<b>Delegated Report (Members Briefing)</b>		<b>Analysis sheet</b> N/A / attached	<b>Expiry Date:</b> 16/08/2016
			<b>Consultation Expiry Date:</b> 21/07/2016
<b>Officer</b>		<b>Application Number(s)</b>	
Charles Rose		2016/3488/L	
<b>Application Address</b>		<b>Drawing Numbers</b>	
108 St Pancras Way London NW1 9NB		Refer to decision notice	
<b>PO 3/4</b>	<b>Area Team Signature</b>	<b>C&amp;UD</b>	<b>Authorised Officer Signature</b>
<b>Proposal(s)</b>			
Discharge of condition 7 (specifications for new shopfront) granted under reference 2013/1566/L dated 03/09/13 for excavation to extend basement level and erection of two storey extension at rear of dwelling house (Class C3), external alterations to shopfront and fenestration, and associated internal works.			
<b>Recommendation(s):</b>	<b>Recommendation 1:</b> Grant listed building consent  <b>Recommendation 2:</b> That the Borough Solicitor issue a Listed Building Enforcement Notice under Section 38 of the Town & Country Planning Act 1990 as amended, requiring the replacement of the unauthorised shopfront, and officers be authorised in the event of non-compliance to prosecute under Section 43 or appropriate power and/or take dire

Figure 1. Proposed shopfront plan with previous shopfront outlined in red

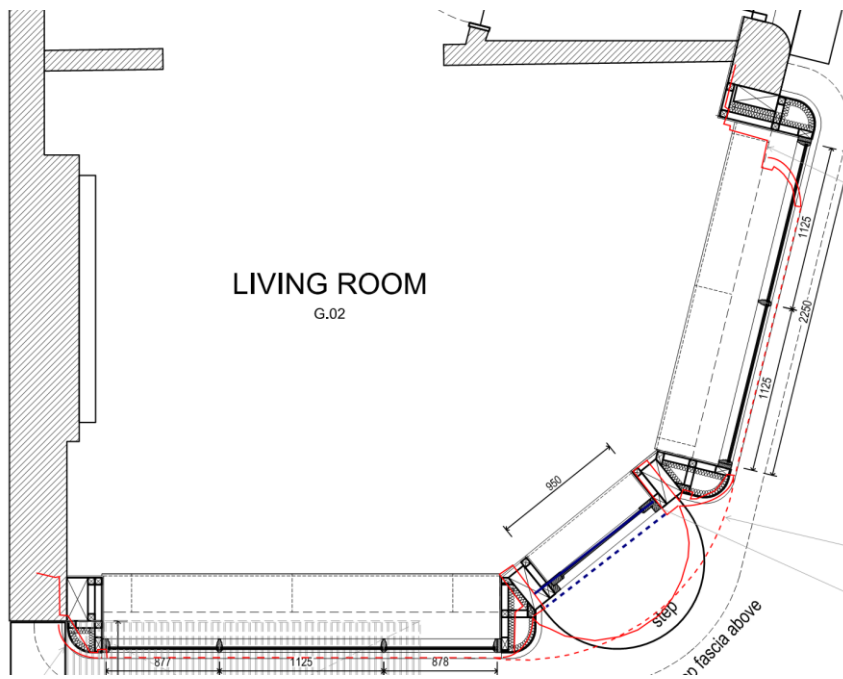
- the curves on the pillars are sharper (smaller diameter) on the proposed

This is correct however as can be seen from the overlays in figures 1 and 2 below the margin of difference between the curve of the pillars is not considered to be sufficient to refuse the proposal

Figure 4 Proposed st pancras way elevation with the existing overlaid in red.

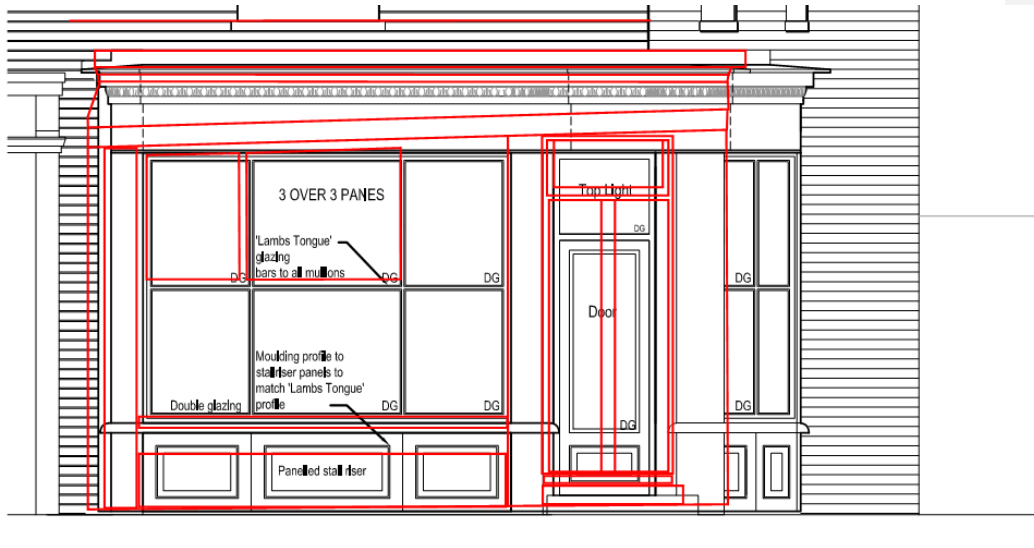
- the missing return on the curved pillars [left and right of the windows] against brick wall;

The details referred to are circled in figure 3. These have not been shown to be reinstated.

Figure 5 section and plan through the canopy

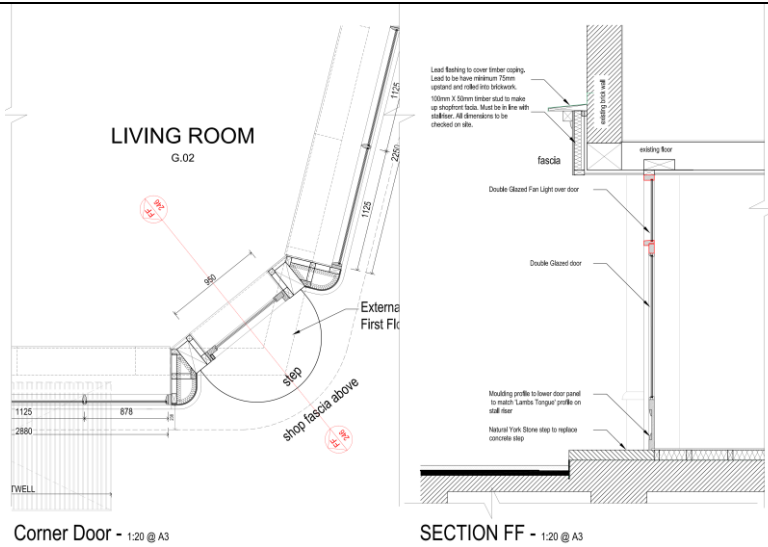
- there is no detailed vertical section showing the construction of the canopy;

These details have been provided. The section, in conjunction with the plans show the canopy would match the photograph of the previous shopfront shown in figure 3. The proposed canopy is shown in figure 5.

Figure 7. showing a plan of the side entrance door. The black outline is the proposed with the grey the original survey plans

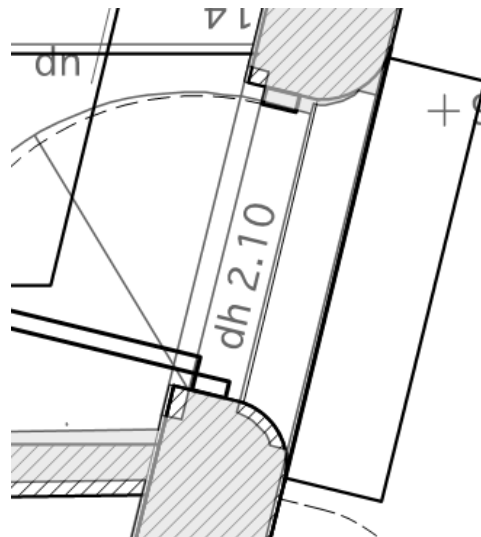
- the curves and returns on the side door pillars are not accurate;

It is not clear from the plans if the curved pillars have actually been changed. However as you can see from figure 7 the curves almost match those from the original survey
